Service Letter #: SL09-35A51800 **Date:** 03/13/2015

Part/Assembly #: 35A-51800 5.00 X 6.00 (6.00-6) Wheel Assembly, Oil Bath Type.

Float Model/Aircraft Affected: 3400 Amphibious model floats, Float Serial Numbers 508-

Fig. 3 – 35A-51800 5.00 X 6.00 (6.00-6) Wheel Assembly, Oil Bath Type.

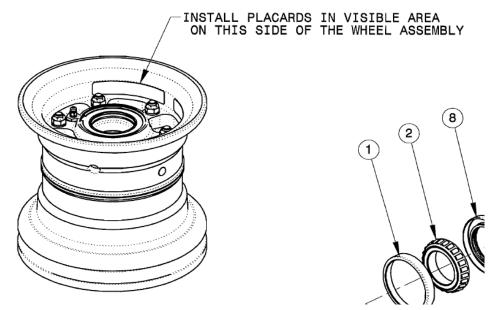
A small batch of part 35A-51800 (Wheel Assembly, Oil Bath Type) were incorrectly labeled with part 35A-51620 (TSO Placard). Correct part is 35A-51820 TSO Placard, Aerocet 35A-51800 Wheel Assembly.

Replace incorrect 35A-51620 Placards with correct 35A-51820 TSO Placard as shown in Fig 3. This is to be accomplished during the next scheduled maintenance period, not to exceed the next 100 hour or annual inspection.

Note: To replace placard use a non-metallic object with pointed edge to lift one corner of the existing placard, once corner is lifted remove by hand. Clean the wheel surface with acetone to remove all residual adhesive. Incorrect placard is shown in Fig. 1 and correct TSO Placard is shown in Fig. 2.
